ADDENDUM I

SUBJECT: District 4 Parks, (ID No.: 23-03974), Date of Issue: October 17, 2025;
Scheduled to Close: November 18, 2025

THIS NOTICE SHALL SERVE AS ADDENDUM NO. 1 – TO THE ABOVE REFERENCED INVITATION FOR BIDS

MED-L3.2

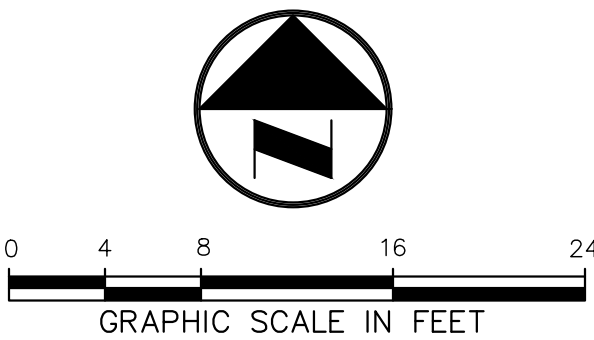
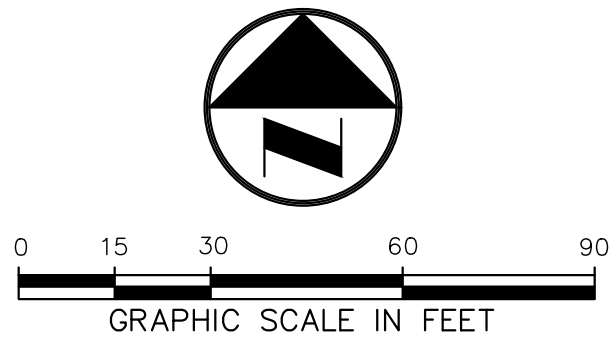
Question 4: The hardscape schedule code numbers on plan sheet MED-L3.2 do not coincide with what the item is on drawing. Please clarify.

Response: Codes adjusted. See revised plans.

DESIGN	DRAWN	DATE
SDS	EEO	AUG 2025
SHEET NO.		
SW-L1.0

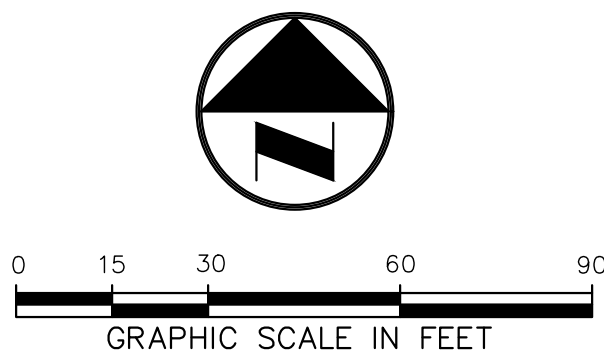
REVISIONS			
NO.	DATE	DESCRIPTION	BY
1	11/09/25	ADJUSTED LIMIT OF WORK	HRM

SW-L3.0

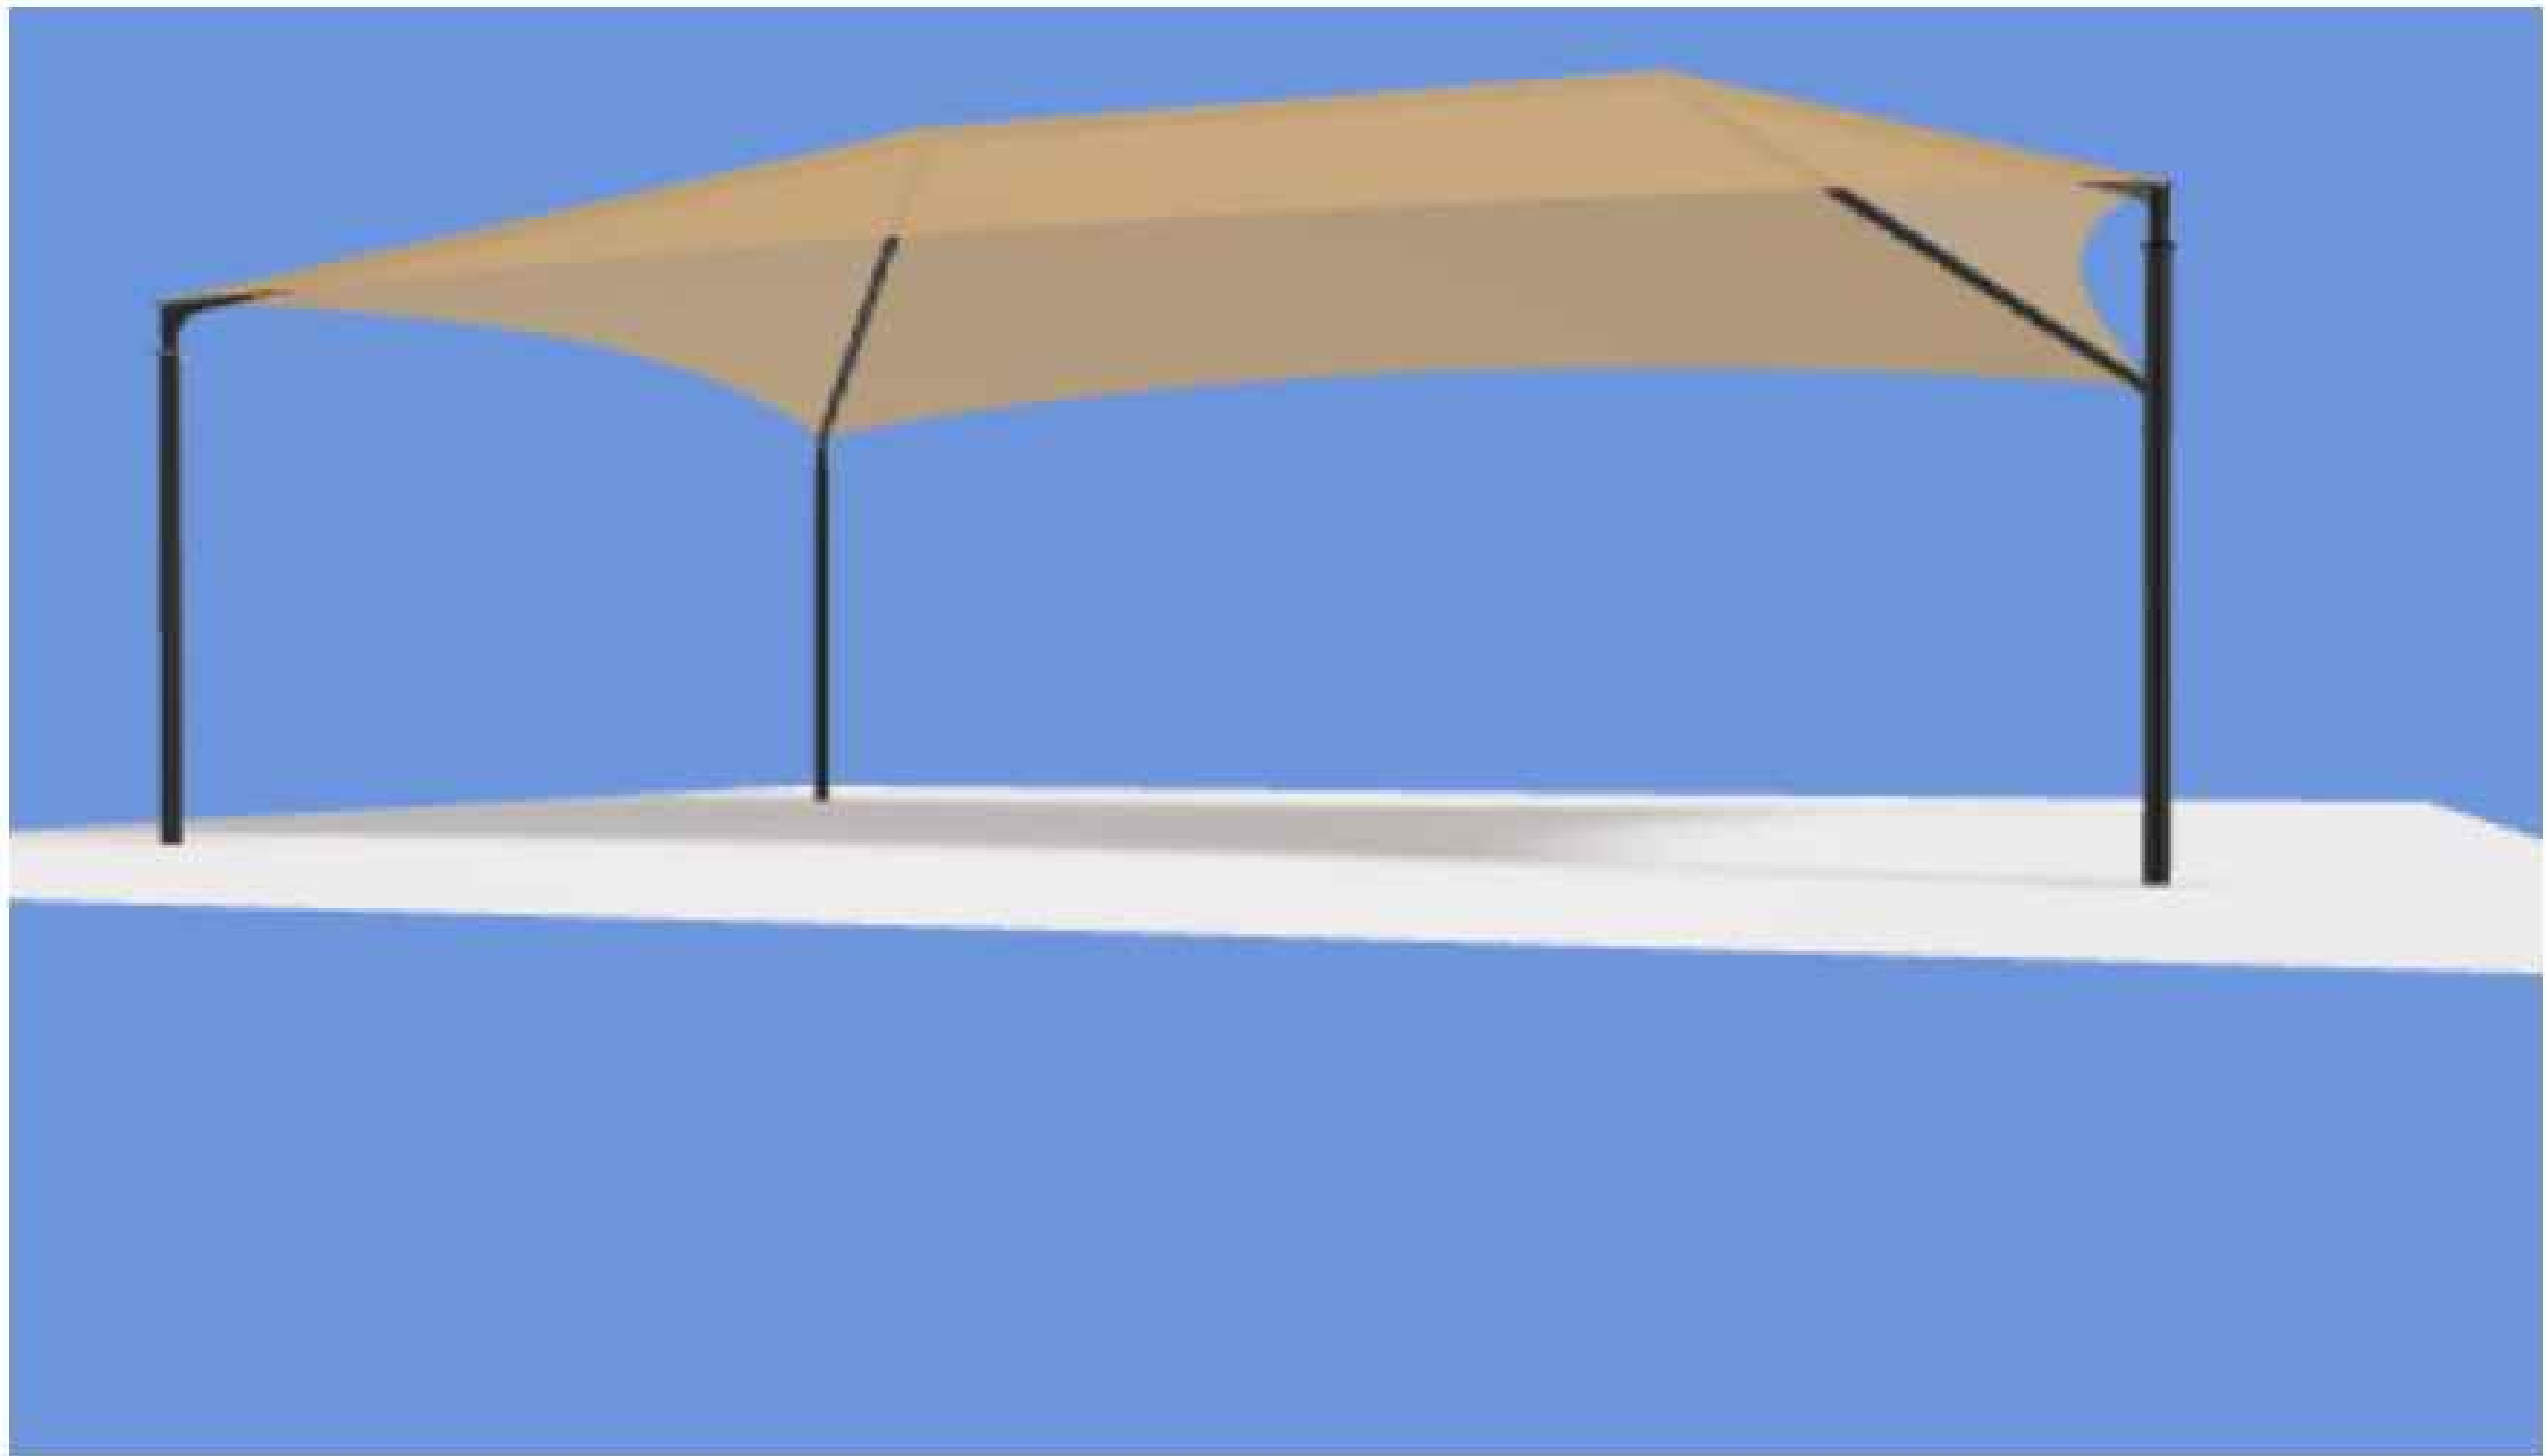
NO.	DATE	DESCRIPTION	BY
1	11/09/25	ADJUSTED LIMIT OF WORK	HRM

SW-L3.1

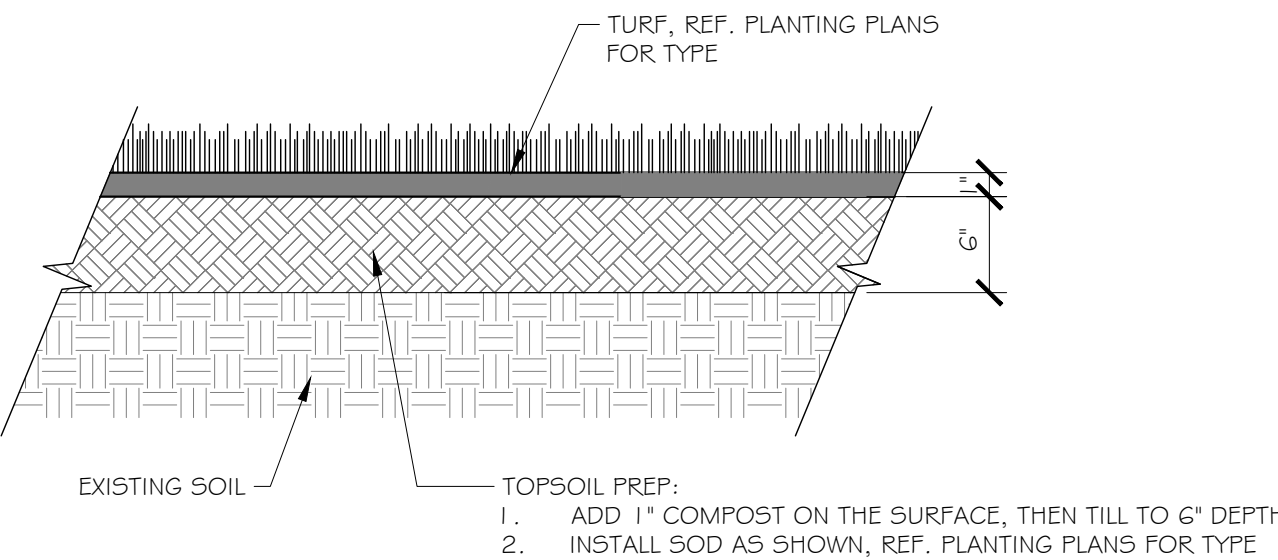
REVISIONS			BY
NO.	DATE	DESCRIPTION	HRM
1	11/05/25	ADJUSTMENT OF DETAIL NOTE

SHEET NO.
SW-L4.0

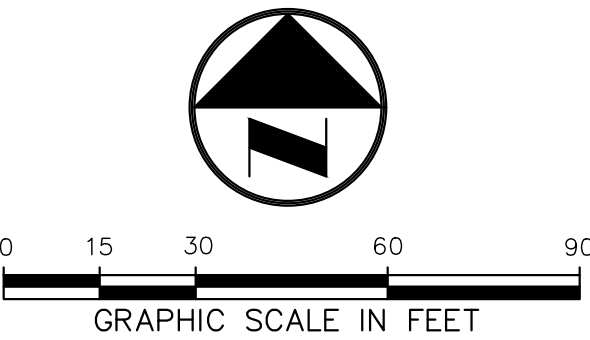
REVISIONS			BY
NO.	DATE	DESCRIPTION	HRM
1	11/09/25	ADJUSTED LIMIT OF WORK, ADDED SOD
